**From:** "PHILLIP BARR" <pharb2@msn.com>  
**To:** <nrcprep@nrc.gov>, "nmlady2000" <nmlady2000@hotmail.com>,  
<sandra\_ely@nmenv.state.nm.us>, "Karen Keith" <keithd2@cox.net>, "mlgav" <mlgav@hotmail.com>  
**Date:** Wed, Nov 10, 2004 2:54 PM

source EIS for the National Enrichment Facility in Lea County New Mexico

Figure E-9 Average 24-Hour Concentrations of Pollutants in Strong Southerly Winds

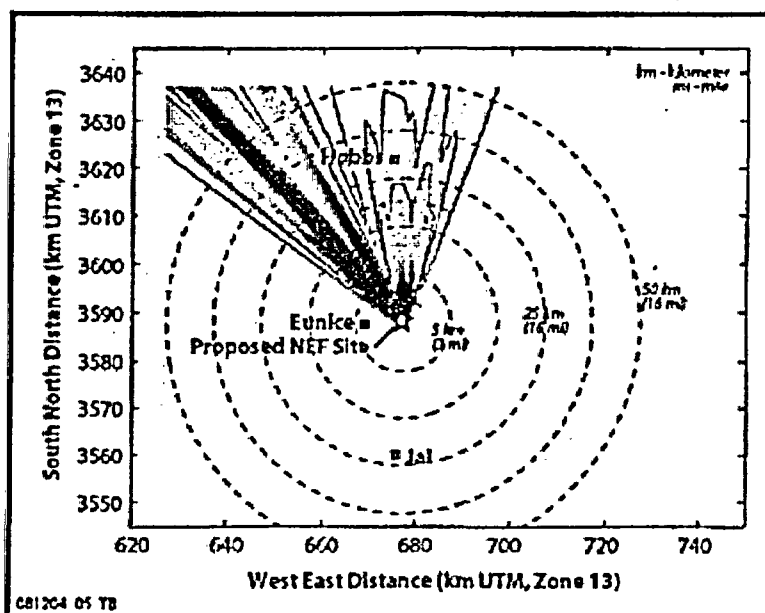
Seasonal winds from the south, some can be in excess of 50mph, will eventually blow the contaminated soil north over Hobbs.

This poses health risks for everyone between that plant and Hobbs.
